## DEVELOPMENT APPLICATION ASSESSMENT REPORT

<b>Application Number:</b>	DA2021/0371
----------------------------	-------------

<b>Responsible Officer:</b>	Dean Pattalis
<b>Land to be developed (Address):</b>	Lot 234 DP 16327, 14 Argyle Street BILGOLA PLATEAU NSW 2107
<b>Proposed Development:</b>	Alterations and additions to a dwelling house
<b>Zoning:</b>	E4 Environmental Living
<b>Development Permissible:</b>	Yes
<b>Existing Use Rights:</b>	No
<b>Consent Authority:</b>	Northern Beaches Council
<b>Land and Environment Court Action:</b>	No
<b>Owner:</b>	Matthew Jeffrey Tinker Rebecca Jean Tinker
<b>Applicant:</b>	Matthew Jeffrey Tinker

**Image 1. Northern elevation building envelope.**

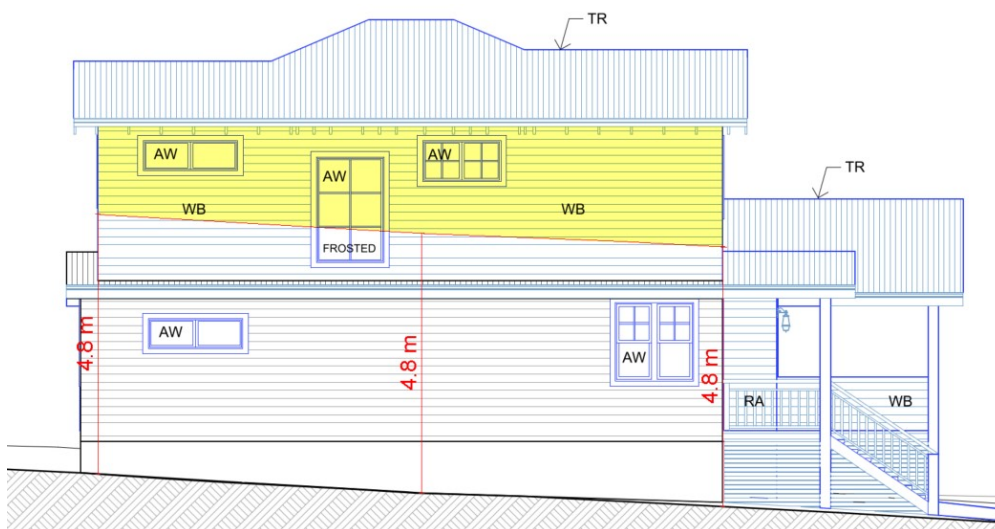
The proposed first floor addition will extend beyond the prescribed building envelope along the northern elevation, as indicated in the image below.

Council may consider a variation to this control for the addition of a second storey where the existing dwelling is retained. As such, a merit consideration is undertaken, see below.

There are three (3) windows along the northern elevation of the first floor level which provide natural light to a sitting room, staircase and Bedroom 2. The proposed window to the staircase will be frosted, the windows for the sitting room and Bedroom 2 have a sill height of 1.9m and 2.1m, respectively. As such, these windows, while outside of the prescribed building envelope, do not give rise to any unreasonable privacy or amenity impacts.
